Notification of Consolidation of package specifications

[Consolidation of package specifications]

Comparison of specifications

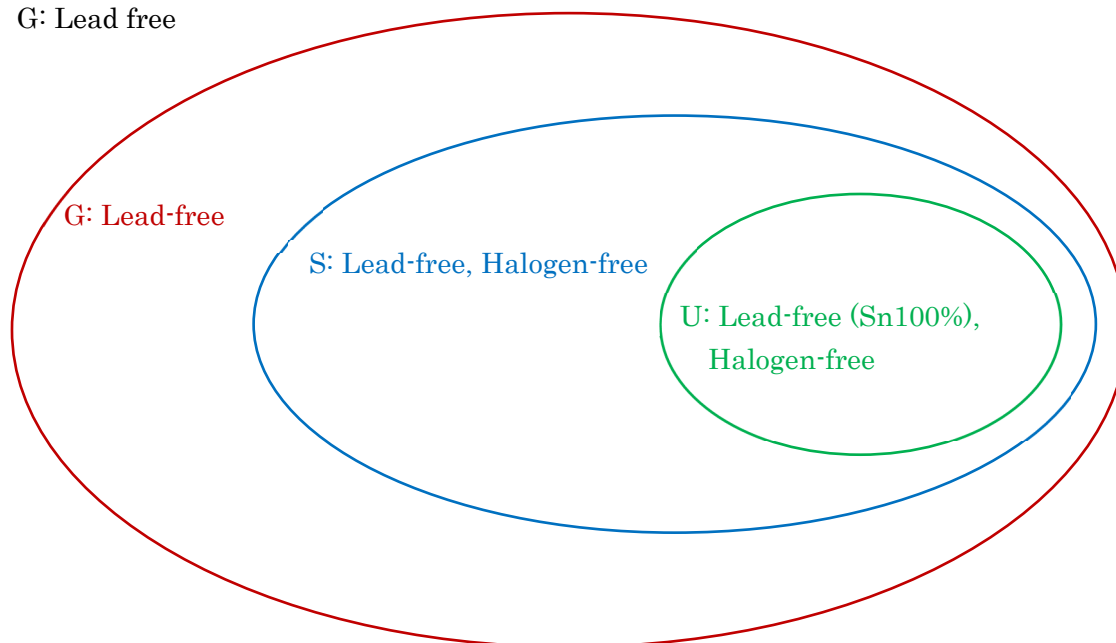
Before: Package specifications are recognized based on the last character of product names (Environmental Code).

U: Lead free (Sn100%), Halogen free

S: Lead free, Halogen free

G: Lead free

After: All products are consolidated into Lead (Pb) free (Sn100%) and Halogen free regardless of the last character of product names (Environmental Code).
